# HISTORIC AND DESIGN REVIEW COMMISSION

**HDRC CASE NO:** 2018-234  
**ADDRESS:** 1126 E CROCKETT ST  
**LEGAL DESCRIPTION:** NCB 585 BLK 1 LOT 2  
**ZONING:** RM-4 H  
**CITY COUNCIL DIST.:** 2  
**DISTRICT:** Dignowity Hill Historic District  
**APPLICANT:** Michael Perez  
**OWNER:** MP2 Urban Development  
**TYPE OF WORK:** Construction of a 2-story single family structure and a 1-story rear carport  
**APPLICATION RECEIVED:** June 29, 2018  
**60-DAY REVIEW:** August 31, 2018  
**REQUEST:**

The applicant is requesting a Certificate of Appropriateness to construct a 2-story single family home with a 1-story rear carport on the vacant lot located at 1126 E Crockett St.

SITE PLAN  
SCALE : 1/8"=1'-0"  
**LOT-2**  
**BLOCK-1**  
**N.C.B.-585**  
**1126 E. CROCKETT STREET**

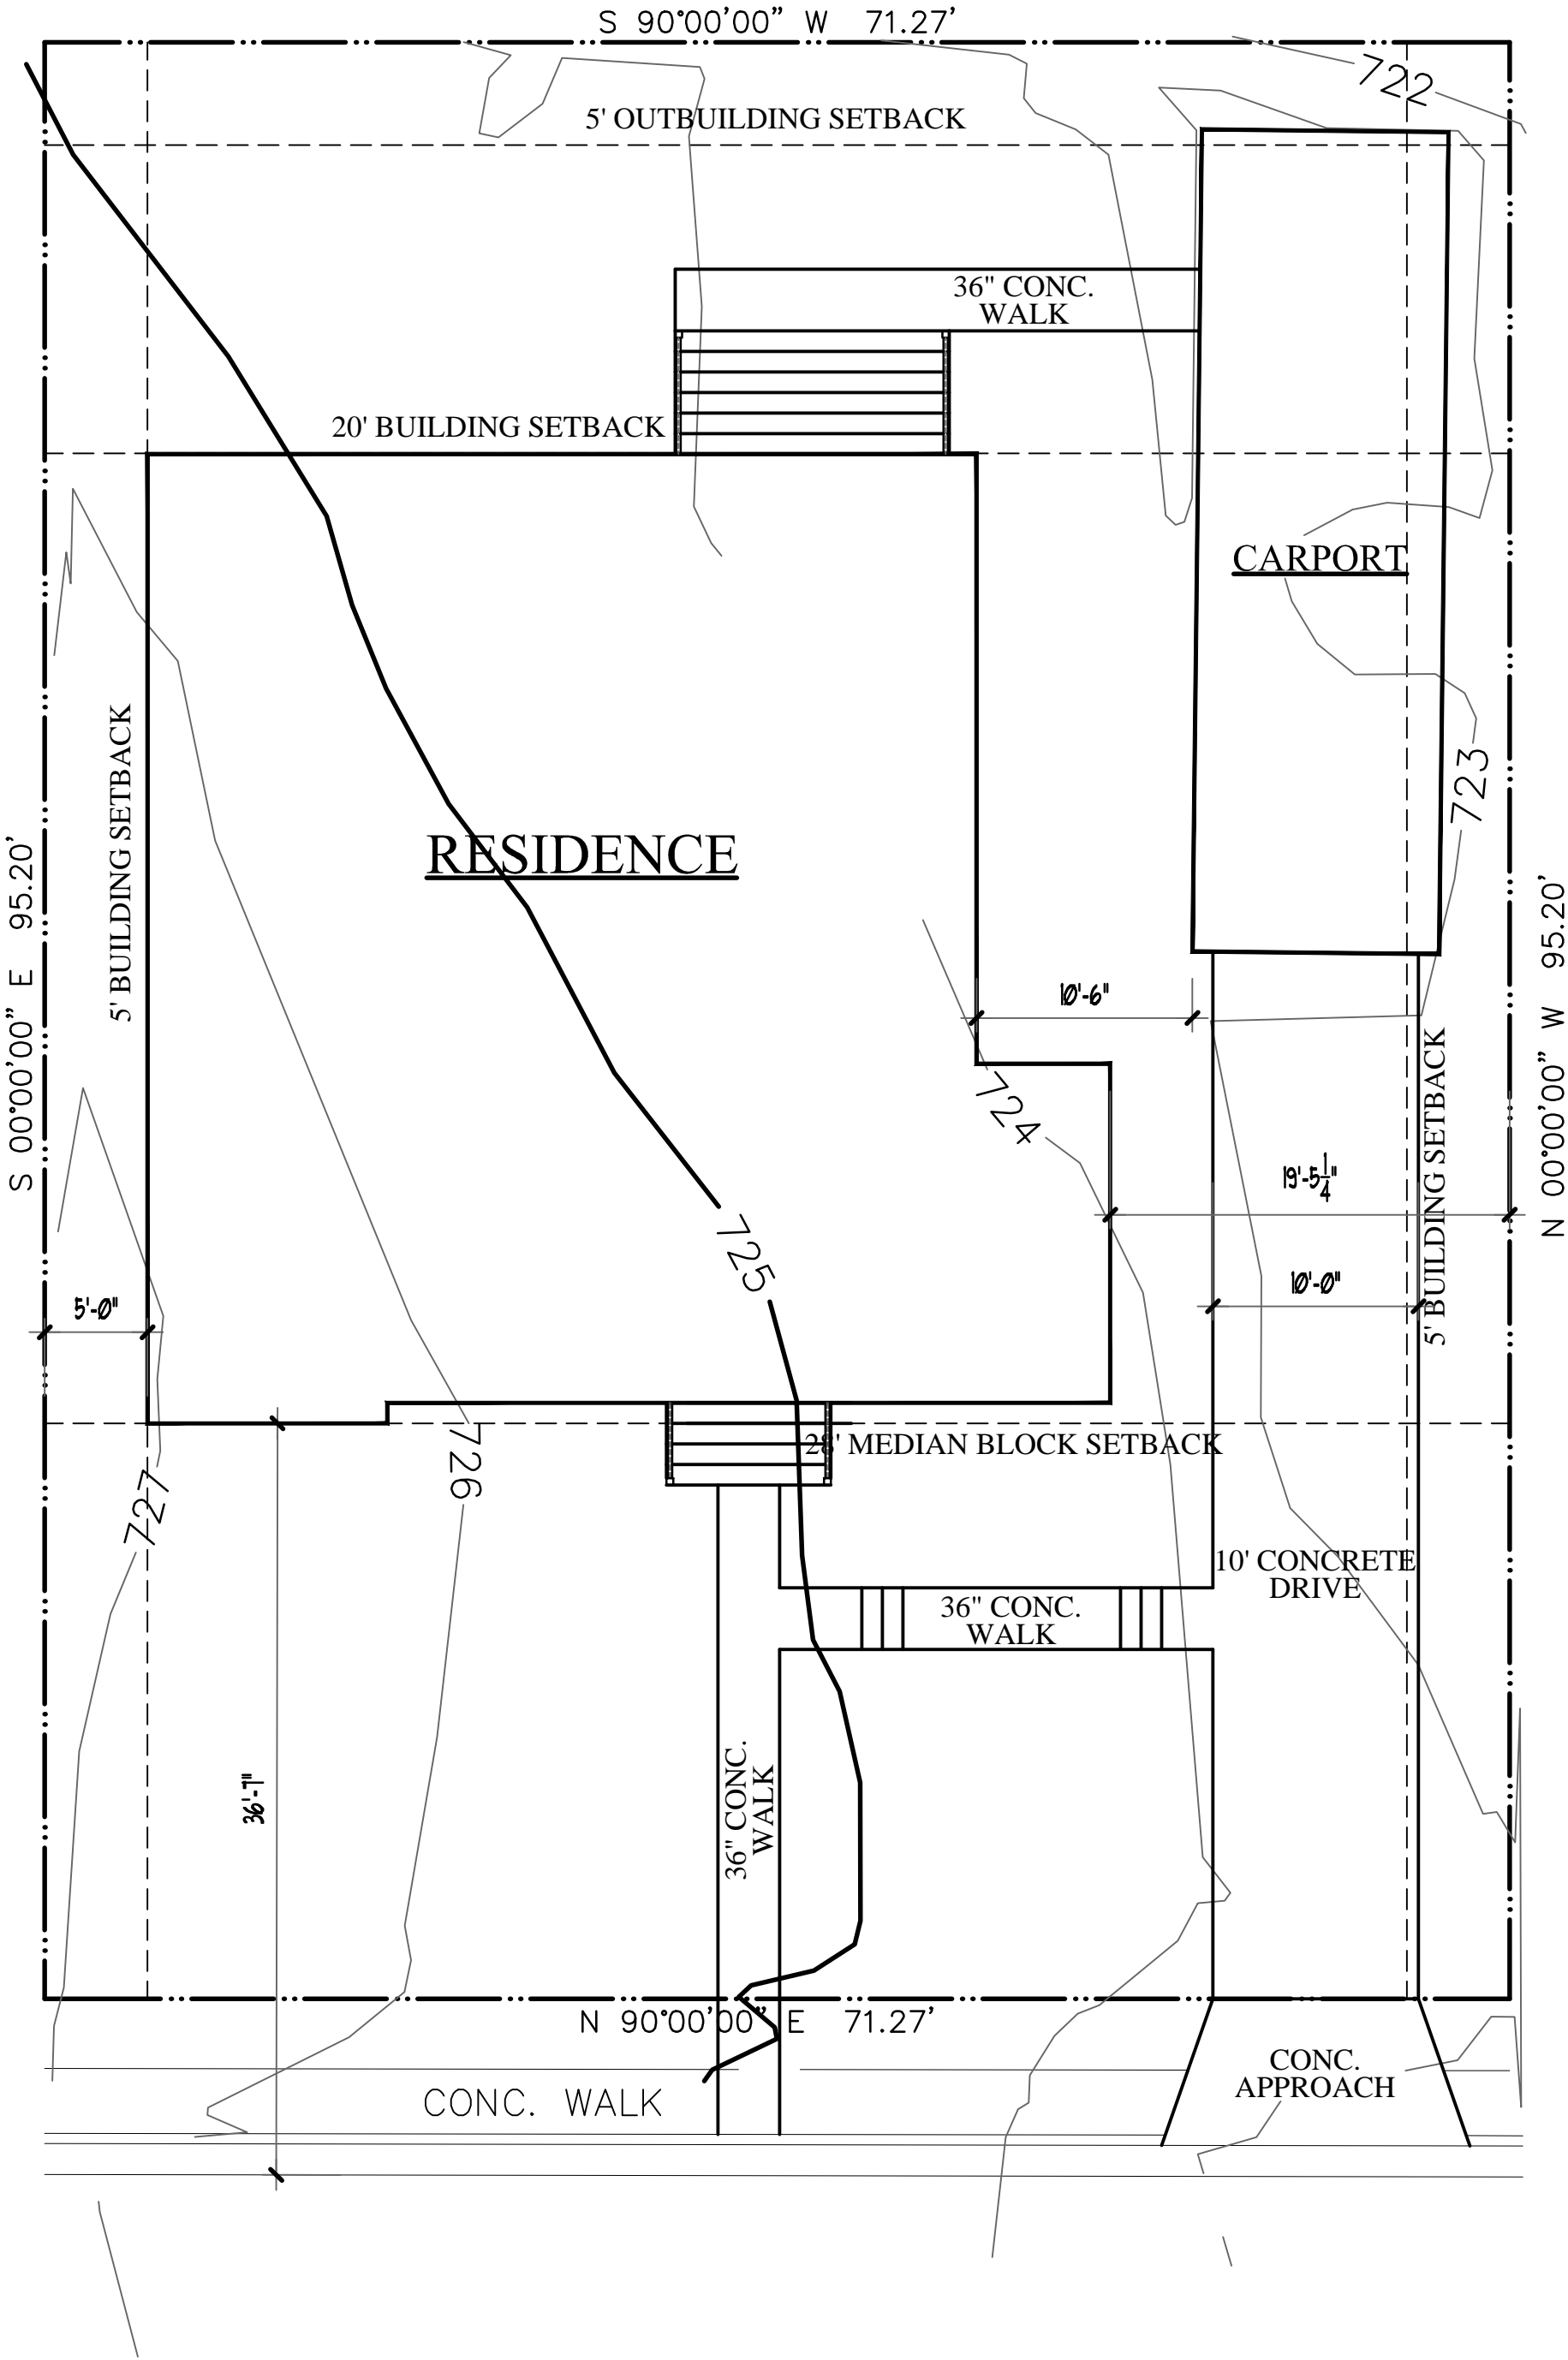
- l. LOT COVERAGE – New construction should be consistent with adjacent historic buildings in terms of the building to lot ratio. The building footprint for new construction should be no more than fifty (50) percent of the size of total lot area. Based on the submitted site plan, the proposal appears to be generally consistent with this Guideline.

- r. DRIVEWAY – The applicant has proposed to install a new concrete ribbon driveway on the west side of the structure. The driveway will terminate at the rear carport entrance. According to the Historic Design Guidelines, driveways in historic districts are typically 10 feet in width maximum. Staff finds the proposal appropriate.

- s. HARDCAPING – In addition to the driveway, the applicant has also proposed a new 36” wide concrete walkway leading to the front porch of the structure. Another 36” wide concrete walkway will run parallel to the previous walkway and connect with the ribbon drive. Due to the grade change, the walkway running east-west

will have two sets of stairs. The applicant has also proposed a 36" wide concrete walkway at the rear of the structure connecting the carport to the rear porch staircase. Staff finds the proposal generally consistent with the Guidelines.

- iii. That the ribbon driveway be no wider than 10 feet and the tapered concrete apron be no wider than 12 feet at its widest point.

**FRONT ELEVATION**  
SCALE : 1/4"=1'-0"

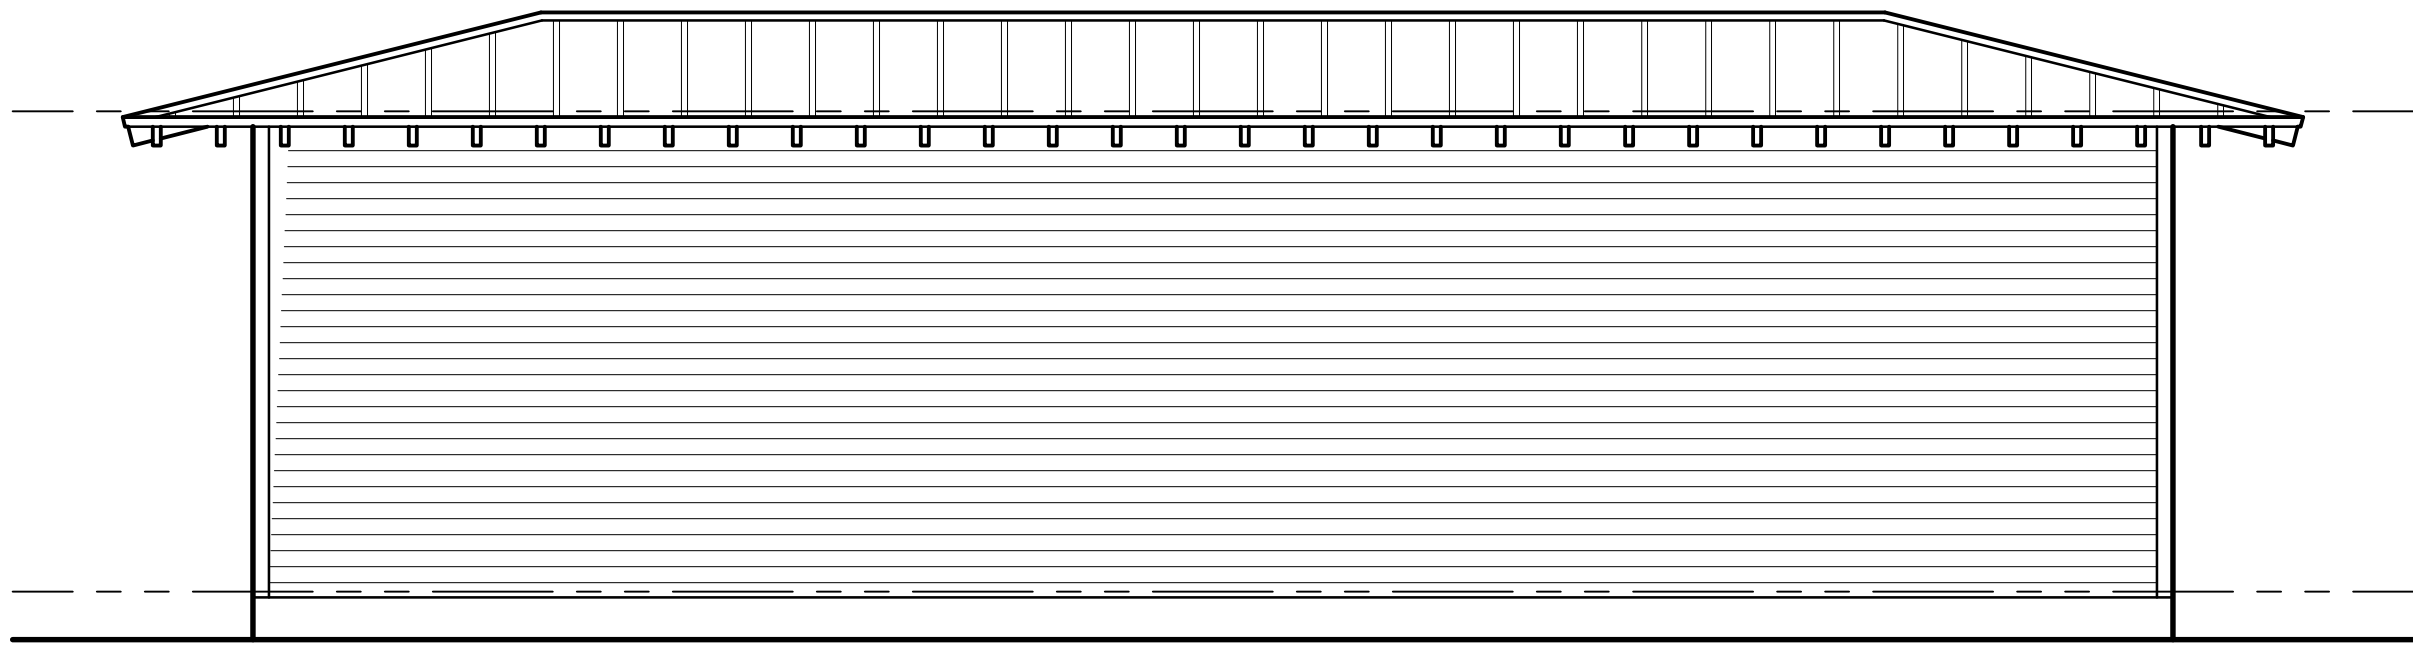
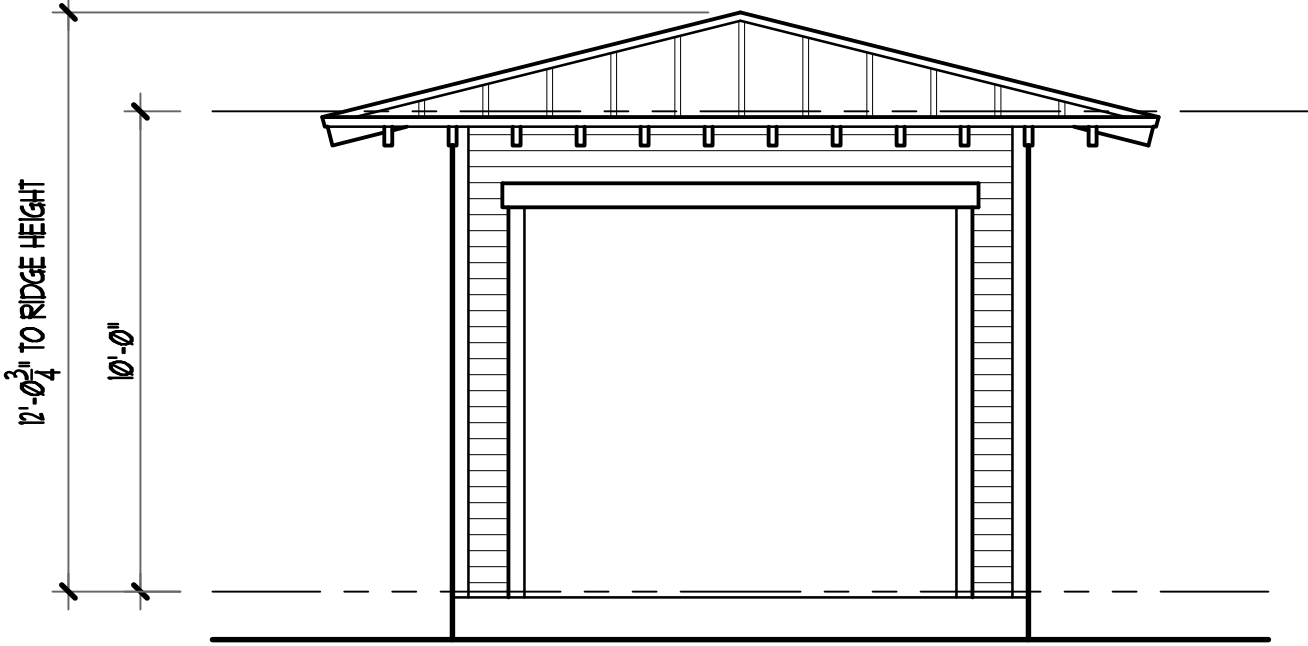
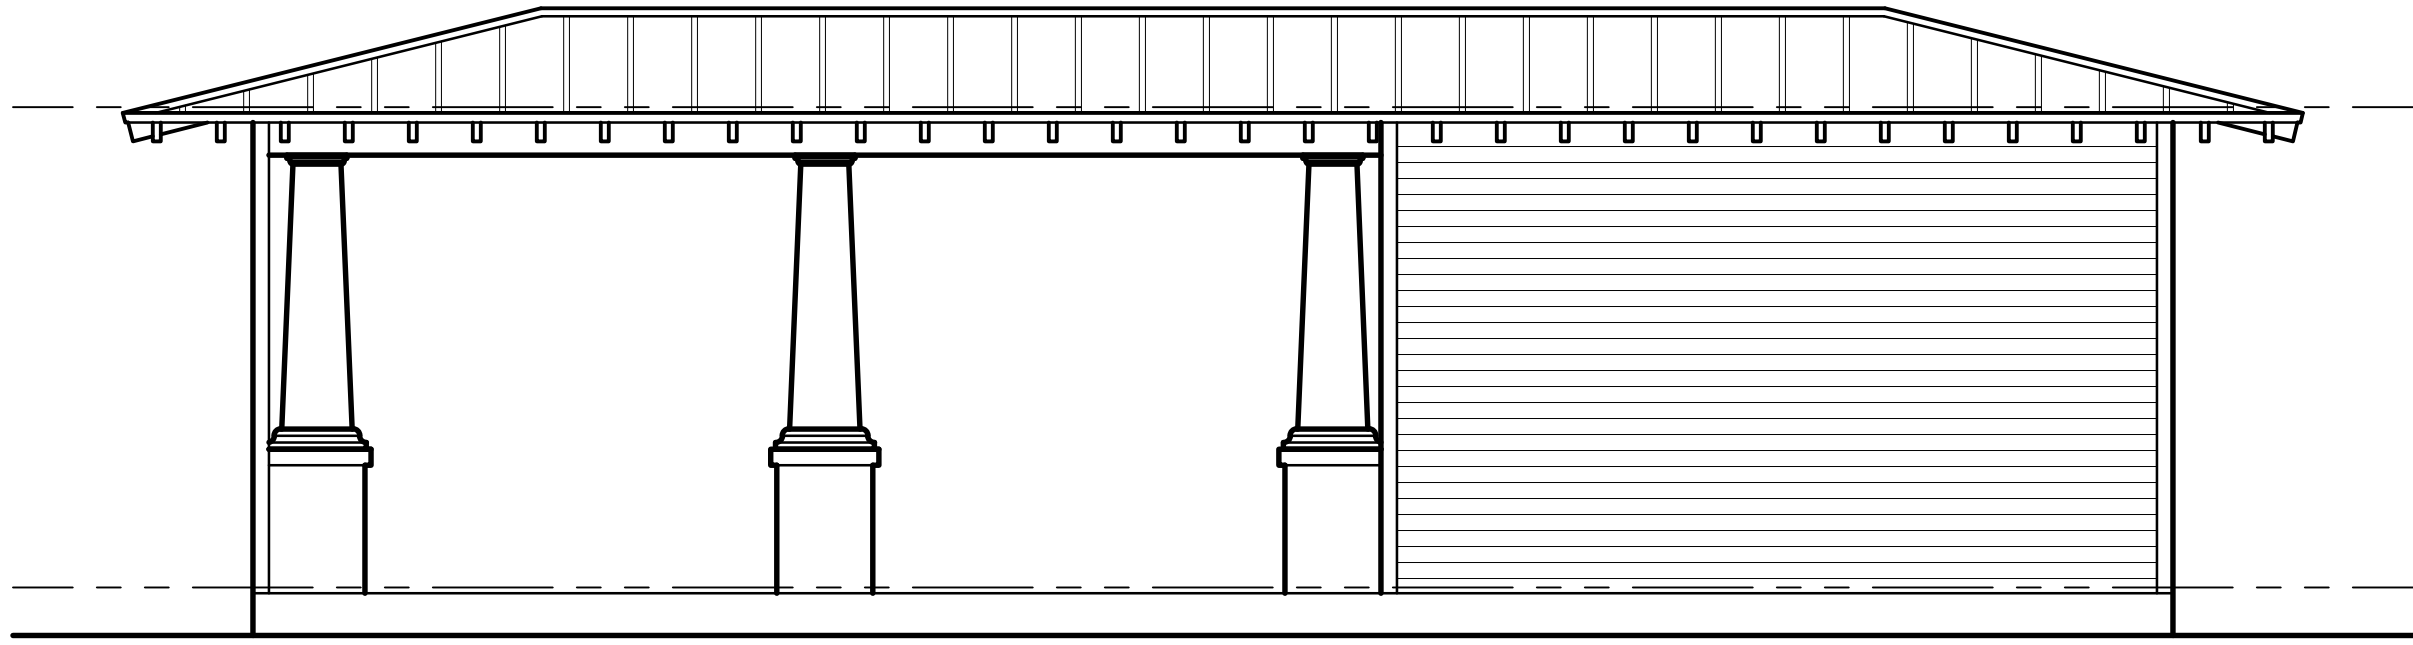
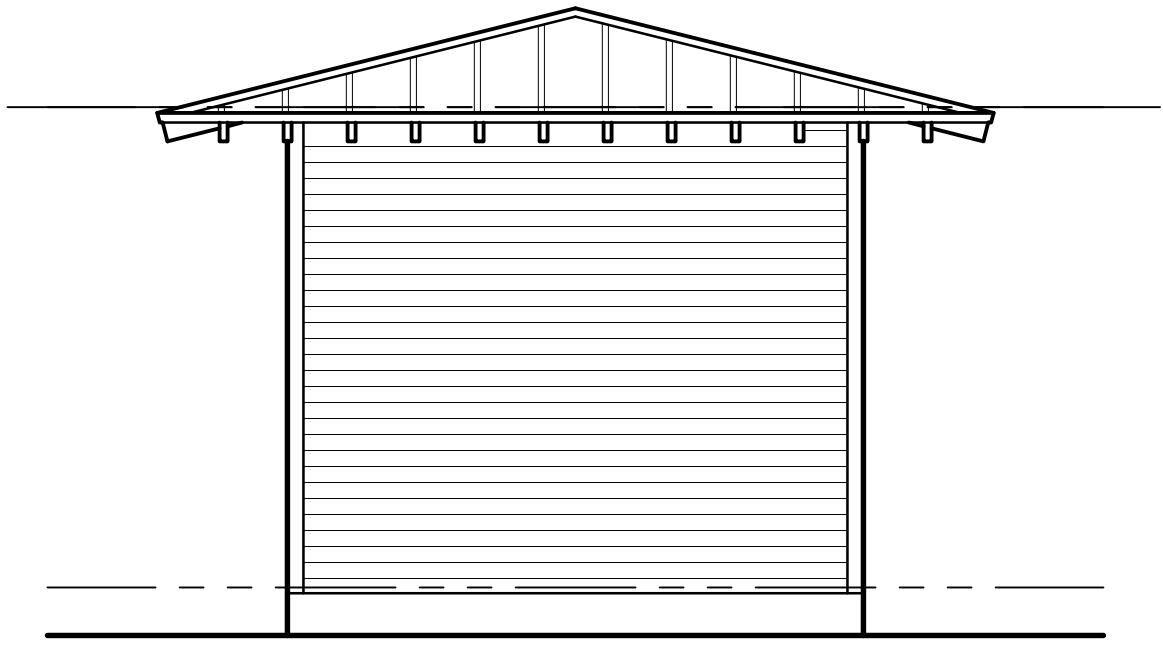
- f. SCALE & MASS – The applicant has proposed a 2-story primary structure. Per the submitted application, the primary ridgeline of the structure is 26'-8 1/16" from the western elevation of the property, including the foundation height. This is a reduction of approximately 3 feet from the proposal submitted for conceptual approval. The applicant has also reduced the overall width of the structure. Guideline 2.A.i stipulates that the height and scale of new construction should be consistent with nearby historic buildings and should not exceed that of the majority of historic buildings by more than one-story. This block of E Crockett is characterized exclusively by 1-story single family homes. However, the change in grade from N Pine to the east towards N Olive to the west results in the 1-story structures at the intersection of N Pine and E Crockett to be higher in elevation. Staff finds that this elevation change may result in an opportunity for a structure taller than 1-story to be appropriate within the context of the block. Staff finds the scale and mass generally appropriate for the site.

- h. ROOF FORM – The applicant has proposed a primary hipped roof form . The front unit also contains a front

gable. These roof forms are found throughout the Dignowity Hill Historic District as well as this block of E Crockett. Staff finds the proposal consistent with the Guidelines.

- i. PORCH – The applicant has proposed a 1-story, asymmetrical, wraparound front porch. The porch will extend towards the street on the front façade and wrap around to the western edge of the structure. Though dimensions are not indicated on the drawings, the porch will feature a depth of approximately 6 feet with a total square footage of approximately 293 square feet. According to the Historic Design Guidelines, new construction should not attempt to mirror or replicate historic features, and new structures and design elements should not be so dissimilar as to distract from or diminish the historic interpretation of the district. The proposed porch pulls from traditional Craftsman-style language, as evidenced by the location and form, exposed rafter tails, tapered columns, and brick bases. The proposed tapered columns are simple in design relative to historic Craftsman architecture. Staff finds the proposed porch appropriate.

- j. WINDOW & DOOR OPENINGS – According to the Historic Design Guidelines for New Construction, window openings with a similar proportion of wall to window, as compared to nearby historic facades, should be incorporated. Similarity is defined by windows that are no larger than 25% in size and vary no more than 10% in height to width ratio from adjacent historic facades. The applicant has proposed several window and door openings that generally feature sizes that are found on historic structures. As compared to the submittal for conceptual approval, the applicant has removed non-traditional side lite and transom details and has proposed a proportionally-appropriate entry door. Staff finds the window and door openings appropriate.

- k. WINDOW & DOOR MATERIALS – The applicant proposed to install aluminum clad wood windows. The windows will be black. The applicant has proposed a product that features a decorative faux divided lite detail on the top sash. While staff finds the color and material of the windows to be appropriate, staff finds that the faux divided lites are inconsistent with the Historic Design Guidelines and the window policy document. Staff recommends that the windows feature a one over one configuration with no divided lites to be consistent.

- m. MATERIALS – The applicant has proposed materials that include composite wood siding, standing seam metal roofs, and simple wood columns and railings. Staff finds siding and roofing materials to be generally consistent with the Guidelines and compatible for new construction in the district. Staff finds that the siding should feature a smooth finish and an exposure of four inches.

- i. That the standing seam metal roof features panels that are 18 to 21 inches wide, seams that are 1 to 2 inches tall, a crimped ridge seam and a standard galvalume finish.

- ii. That the aluminum-clad wood windows feature a one over one configuration as noted in finding k and meet the following specifications: Meeting rails must be no taller than 1.25" and stiles no wider than 2.25". White manufacturer's color is not allowed, and color selection must be presented to staff. There should be a minimum of two inches in depth between the front face of the window trim and the front face of the top window sash. This must be accomplished by recessing the window sufficiently within the opening or with the installation of additional window trim to add thickness. Window trim must feature traditional dimensions and architecturally appropriate sill detail. Window track components must be painted to match the window trim or concealed by a wood window screen set within the opening.
